**NEW ROOF FRAMING PLAN - PROPOSED (ABOVE EXISTING 3RD FLOOR ROOF)**  
SCALE: 3/16" = 1'-0"

OWNER 781-3 EAST 142, LLC				DESCRIPTION/CONTENTS ROOF FRAMING PLAN AND VRF/E.G. DUNNAGES - PROPOSED				TITLE MILTADIS LEPTOUGROS, P.E. 35-14 168th STREET FLUSHING, N.Y. 11358 Tel. (718) 886-5105 E-mail: zilt35@aol.com	
PROJECT/ADDRESS 781 EAST 142nd STREET BRONX, NY. 10454				DWG No. <b>S-010.02</b>				DATE 3-17-25	
BLOCK 2575	LOT 34	ZONING M1-3	MAP 6C	JOB No. 2286	SCALE AS NOTED	DATE 3-17-25	SHEET No. 11 OF 21	STAMP LICENSED PROFESSIONAL ENGINEER MILTADIS LEPTOUGROS STATE OF NEW YORK

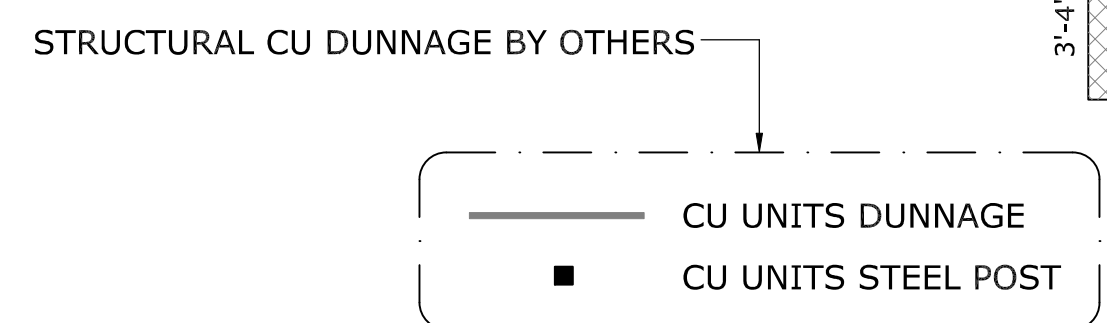
24x36  
2  
ADDED CONDENSER UNITS DUNNAGE AS PER AS-BUILT. REVISED EMR/ECR WALL (FROM CONC. TO CMU). CONVERTED ECR TO STO. RM.
